## **CITY OF LAKE GENEVA PLAN COMMISSION**

**MONDAY, AUGUST 21, 2023 - 6:00 PM**

STAFF REPORT  
To Lake Geneva Plan Commission  
Meeting Date: August 21, 2023

IMPERVIOUS - WITHIN PARCEL 1 - UNIT 1 ONLY-----

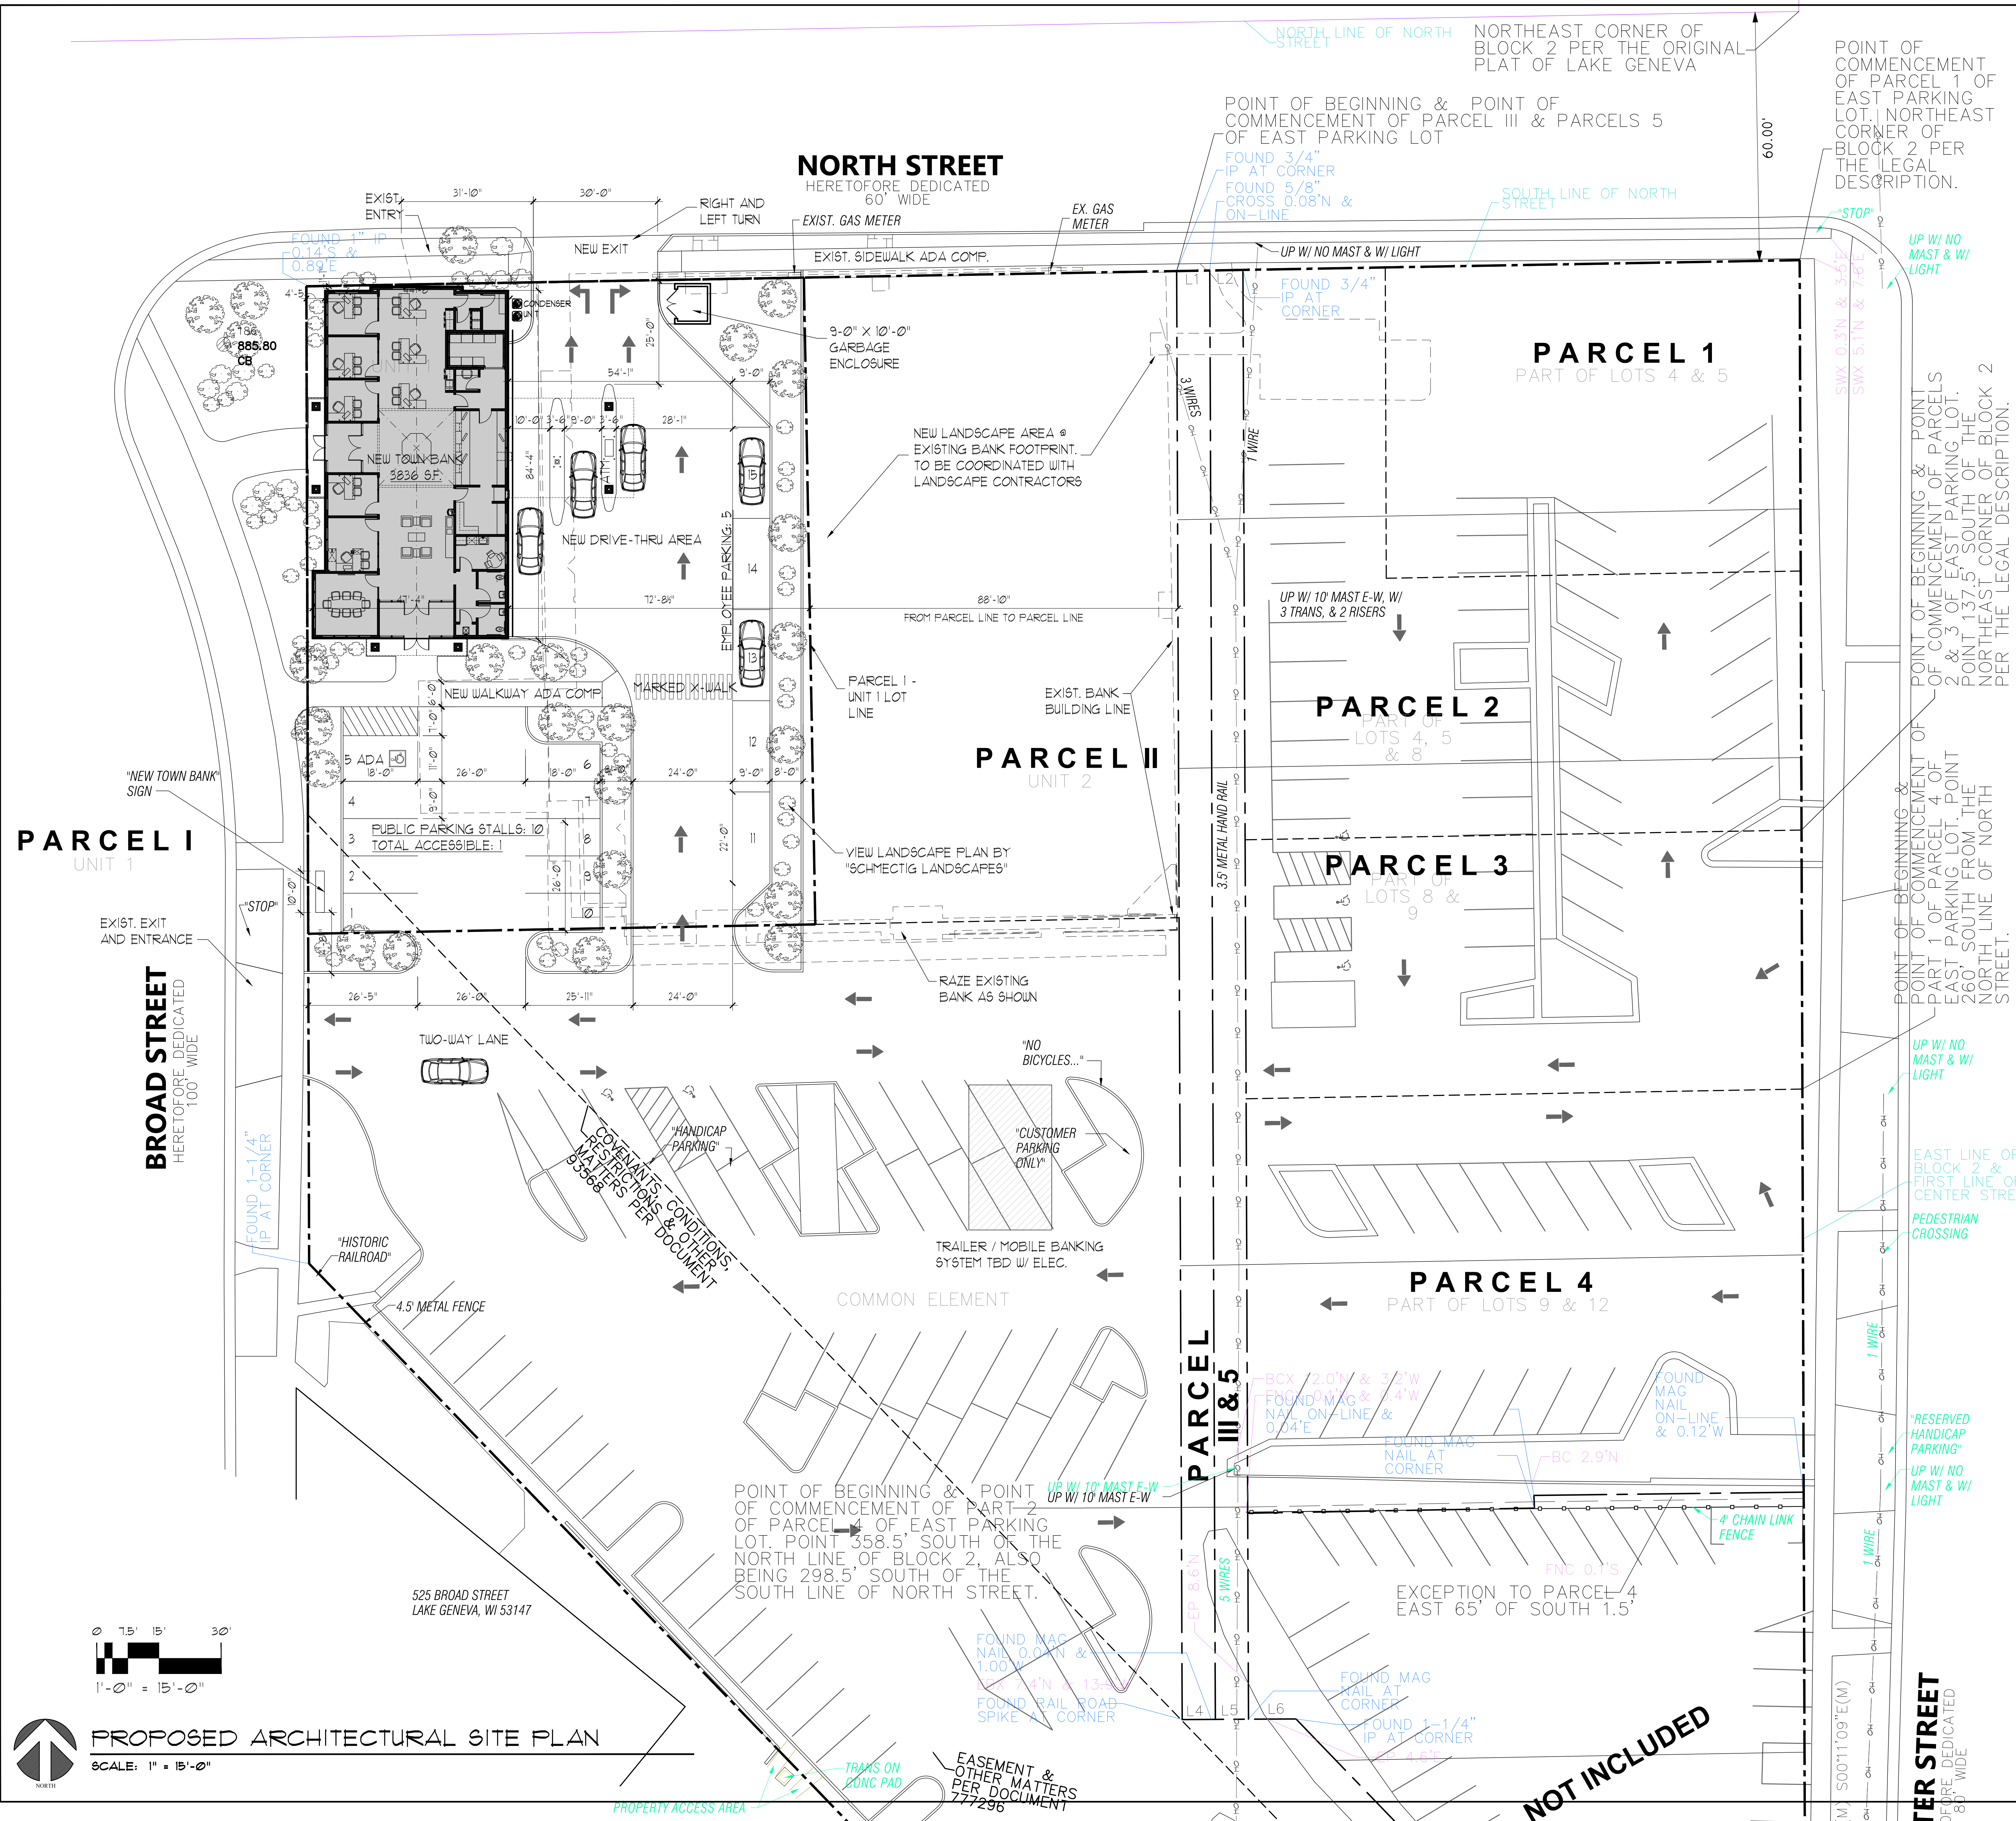
1. Section 78-247 Post-Construction Stormwater Management of the municipal code applies to any “development plan other than residential development with a gross aggregate area of 1.5 acres or more; or any nonresidential land development which creates an impervious area of 0.5 acre or more”. The site data presented on the Architectural Site Plan indicates an impervious surface of 14,686 SF (0.33 acres) within Unit 1 only.

- a. We understand that the proposed project is part of a plan for redevelopment of the larger parcel. The applicability of the stormwater management requirements of Section 78-247 must consider the larger redevelopment plan; and may be phased as development occurs.

- b. Future phasing will affect the stormwater requirements and how each requirement will be addressed. The next phase will likely push the impervious area total over 0.5-acres. From that time forward, stormwater quantity and stormwater quality must be considered for the first and all future phases.

4. New water services shall be constructed of CTS SDR9 Poly Tubing. The notes on Sheet 2 shall be revised to reflect this requirement. The proposed curb stop location shall be shown on the plans.

5. New sanitary services shall be ASTM D303, SDR 35 with gaskets meeting the requirements of ASTM F477. The notes on Sheet 2 shall be revised to reflect this requirement.
